Wollongong Local Planning Panel Assessment Report | 8 March 2022

WLPP No.	Item 2
DA No.	DA-2021/1053
Proposal	Demolition of existing structures, tree removals, construction of multi dwelling housing comprising 11 x 3 bedroom dwellings and Subdivision - Strata title
Property	3-5 James Road Corrimal Lot 7-8 DP 19666
Applicant	McDonough Developments
Responsible Team	Development Assessment and Certification - City Wide Team (KR/MB)

ASSESSMENT REPORT AND RECOMMENDATION

SITE PLAN

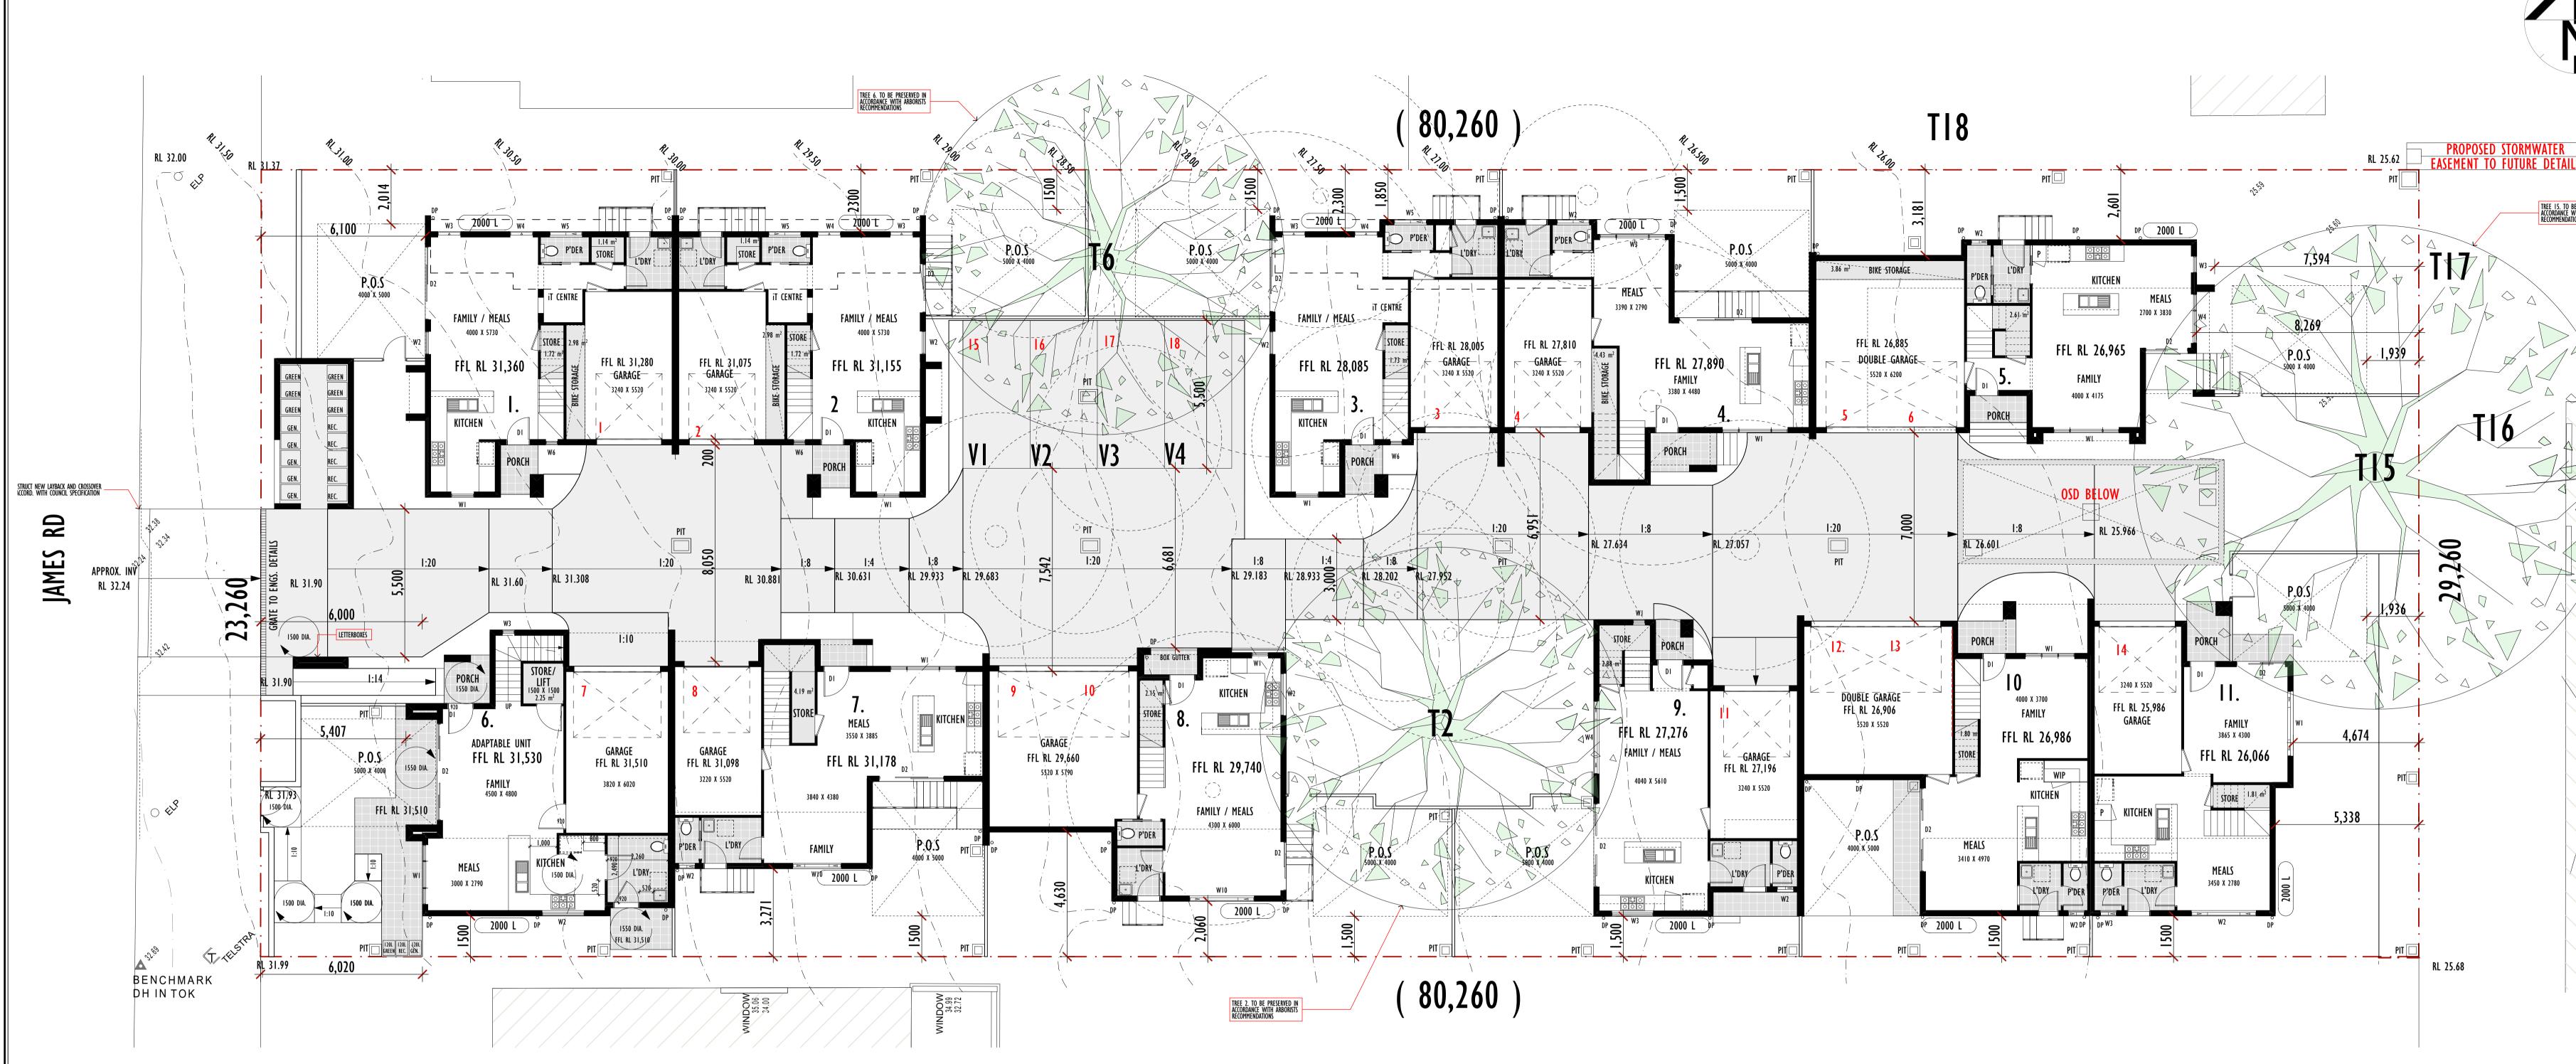
The proposed POS for unit 1 and 6, bin store and ramp access to Unit 6 is likely to have an adverse impact on the streetscape as these structures would be obtrusive and impedes the ability to provide a minimum 1.5m wide landscape strip along the frontage to screen these structures when viewed from the public street.

The proposed bin store and ramp within the front setback impedes the ability to provide a minimum 1.5m wide landscape strip along the frontage.

The site contains a number of significant trees, three (3) of which are proposed to be retained as part of the proposal, these being Tree 2, 6 and 15 as identified in the Arborist Report and on the Site Plan. The proposed design conflicts with the existing trees and is likely to have an adverse impact on the trees.
